UNITED STATES PATENT AND TRADEMARK OFFICE

10/671,233

Office Action Summary

DETAILED ACTION

Fig. 1 Cross-sectional view of VJFET

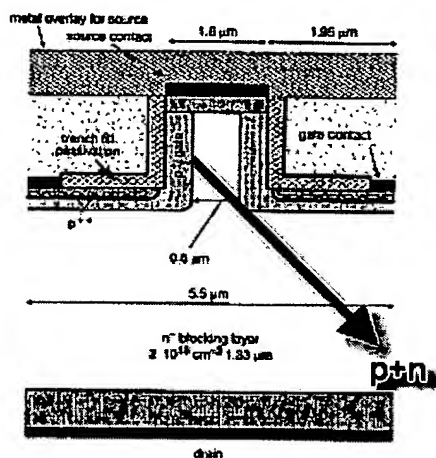
With regard to claims 12,22, Zhao et al. discloses n⁺ type substrate layer serves as a drain layer of heavily doped semiconductor of a first conductivity type and operable as a drain for said transistor; a blocking layer of lightly doped semiconductor of the first conductivity type (n⁻-type) formed on top of said drain layer; a channel layer formed on top of said blocking layer; the channel layer having a plurality of vertical channels of the first conductivity type spaced apart by U-shaped regions (p⁺ gate) heavily doped semiconductor of the second conductivity type; second conductivity type having an opposite conductivity of the first conductivity type; wherein the sides of the U-shaped regions form vertical gate junctions with said vertical channels; and a source layer of very heavily doped semiconductor of the first conductivity type (n⁺-type) on top of said vertical gate junctions and operable as a source for said transistor; wherein said vertical

gate junctions produce a vertical channel opening of a uniform width for operation of the VJFET.
(Note see attachment below, fig. 1 of Zhao et al.).

With regard to claims 13,23, Zhao et al. discloses the U-shaped regions are doped by angled ion implantation. (Note lines 19-23, page 322, see attachment above, fig. 1 of Zhao et al.).

With regard to claims 14,24, Zhao et al. discloses gate ohmic contacts to very heavily doped semiconductor of the second conductivity type (p++-type) formed on the inside bottom of the U-shaped regions. (Note see attachment above, fig. 1 of Zhao et al.).

With regard to claims 15,25, Zhao et al. discloses passivation regions covering the sides of the U-shaped regions, at least part of the gate ohmic contacts, and the sides of the source layer on top of said vertical gate junctions. (Note see attachment above, fig. 1 of Zhao et al.).

With regard to claims 16,26, Zhao et al. discloses a dielectric fill layer filling an area between the sides of the passivation regions. (Note see attachment above, fig. 1 of Zhao et al.).

With regard to claims 17,27, Zhao et al. discloses a metal ohmic contact layer on top of the source layer. (Note see attachment above, fig. 1 of Zhao et al.).

With regard to claims 18,28, Zhao et al. discloses the VJFET is a normally-off transistor. (Note lines 4,5, page 322, see attachment above, fig. 1 of Zhao et al.).

With regard to claims 19,29, Zhao et al. discloses vertical gate junctions (pn junction) are perpendicular to said source layer. (Note see attachment above, fig. 1 of Zhao et al.).
